**Subject:** RE: Thirley Cotes NYM/2018/0499/LB

Mrs Hilary Saunders MRTPI  
Planning Team Leader  
Development Management

Proposed Rowan Cottage  
 Thirley Cotes Farm  
 Harwood Dale, Scarborough  
 P & G Durbin Properties

Section B / B - Hornbeam

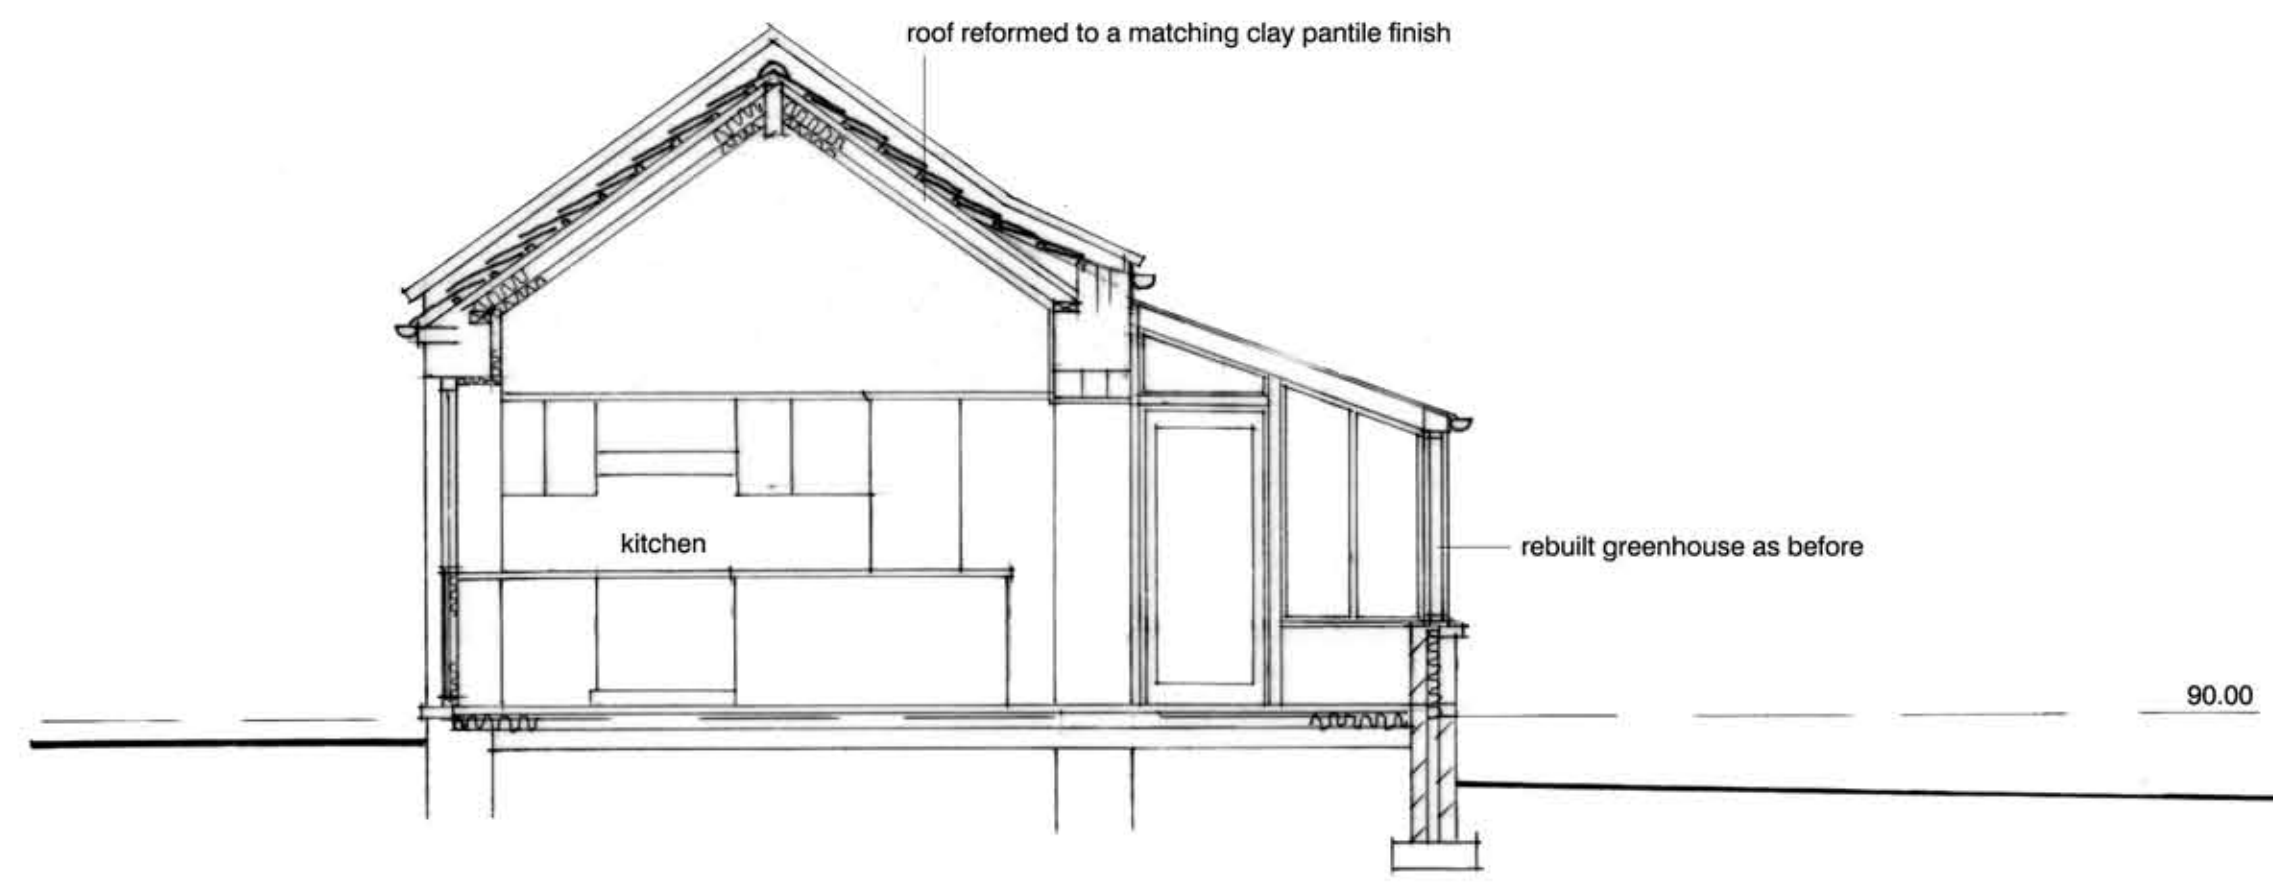
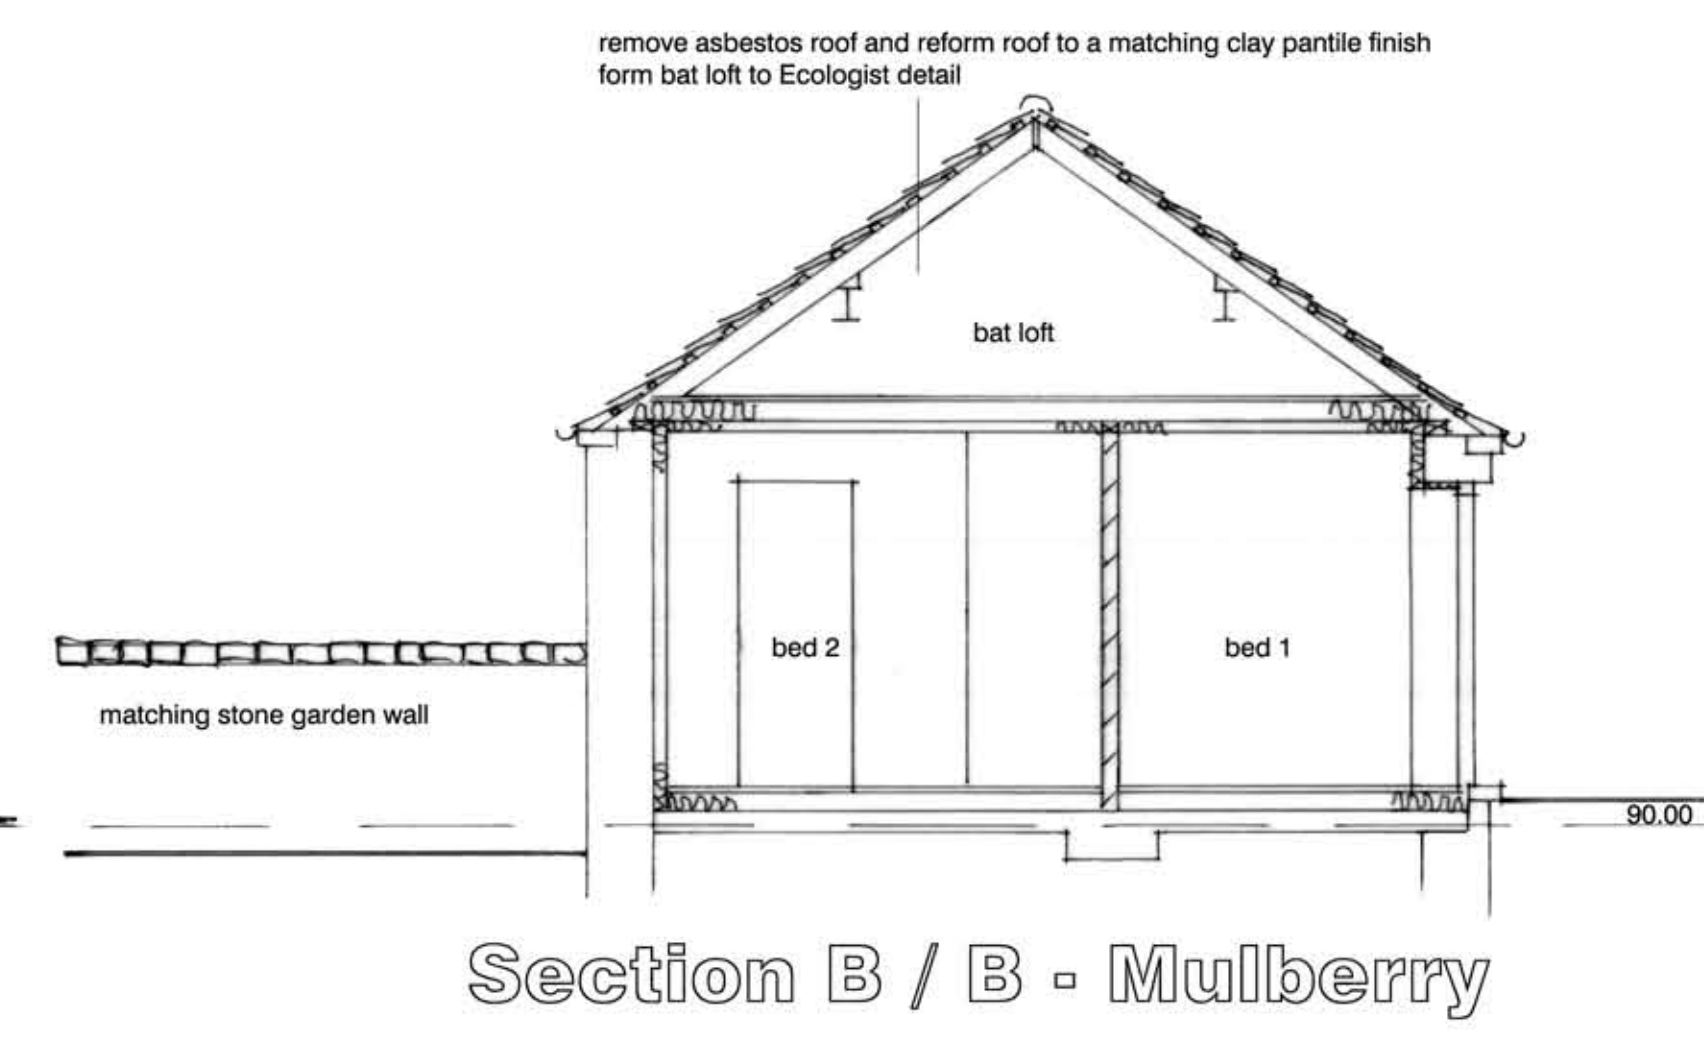
**Hornbeam** - The south gable appears a little cluttered. Please could the proposed window be omitted or at least reduced in size and an alternate suitable location be

**Hot tub area** - The area surrounding the hot tub to hornbeam has altered; the earlier arrangement, ie not on a raised platform is more appropriate.

2. Concerning roof windows I would propose 'the conservation range' from the Roof Light Company with CR10 / 517mm x 980mm to all the roof lights except over the kitchen to Rowan and Mulberry to be CR14's / 821mm x 1133mm. I have revised the drawings and moved a couple to reduce regularity.
3. On Hornbeam I have shown the owl box removed as this will not be needed once the owl loft above is in use. I have also reduced the size of the window – it does need to be suitable for means of escape.
4. Concerning flues I have put a general note on the drawings advising that they are to be kept as low as possible.
